London Borough of Tower Hamlets

Malting and Brewster House

Review of Structural Assessment and
Proposed works

Issue 1 | 11 February 2020

Figure 1 - Approximate floorplan of each block, illustrating the clear span dimensions..

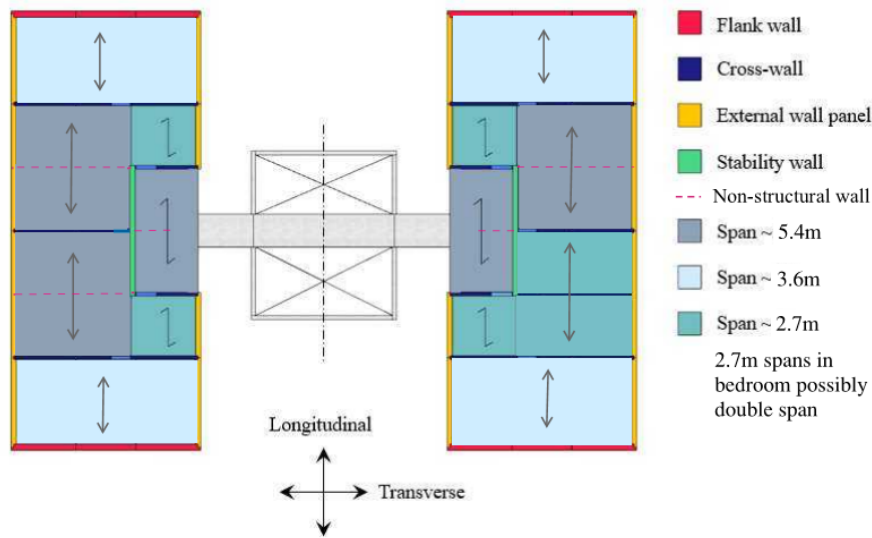
- The 3.6m spanning slabs were calculated by WCC to be overstressed based on the bar diameter found. The BRE independent checks (which we do not have the details of) found no immediate danger of slab failure. We would agree with the WCC assessment. Our checks indicate that generally the slabs are overstressed in bending rather than shear and therefore are unlikely to fail catastrophically.

- The 5.4m spanning slabs would also be overstressed and beyond usual deflection/crack limits under loads required by current Eurocodes[11] and we believe may be relying on the non-loadbearing partitions to limit live load movement. As noted above our checks indicate that generally the slabs are overstressed in bending rather than shear and therefore are unlikely to fail catastrophically.

- The 2.7m spanning slabs are generally within acceptable design limits under normal loading.
- The main loadbearing walls were found to be generally within acceptable load capacities for axial loads.

- The floor slabs which span 3.6m cannot resist accidental loads either up or down (they also cannot resist normal downwards loads in usual conditions see section 6.1.1)

- The floor slabs which span 5.4m cannot resist accidental (or normal) loads up or down without relying on the support of the “non-structural” wall.
- The floors which span 2.7m can resist accidental downwards loads. The BRE also state they can take the upwards accidental blast loads but our preliminary assessment indicates they are slightly overstressed in bending in his condition. Shear/tying at ends is sufficient.

- To strengthen the 3.6m spanning living room slabs to resist normal loads and also the accident upwards and downwards loads. The downwards loads have been taken to be both the blast loading and also a second load case based on the weight of any non-loadbearing partitions and the slab above should they collapse during any accident. The method proposed is to insert reinforcement into the voids in the slab and to grout these into place. Theoretically this works well but success will be highly dependent on workmanship. We understand that tests have been carried out on the proposed system to review constructability and result and these have been positive. We would recommend that a high level of quality control and review is maintained on site.

- To strengthen the 5.4m spanning slabs by inserting a new steel frame against the non-loadbearing partitions to support the slabs at each level, thereby reducing span from 5.4m to 2.65m- 2.7m. This means the slabs can resist downwards accidental loads (and normal loads). This new steel frame also allows the non-structural walls to be lost without risk of disproportionate collapse of the structure. Under uplift loads the slab above the explosion/accidental load will fail. This should not cause any disproportionate collapse issues as the slab below will be able to resist the load of any debris and the structural walls are stabilised by the slabs to either side of the critical span. The details at the base for this frame are not yet determined and local site investigation has been specified to confirm this detail at an early stage of the site works.
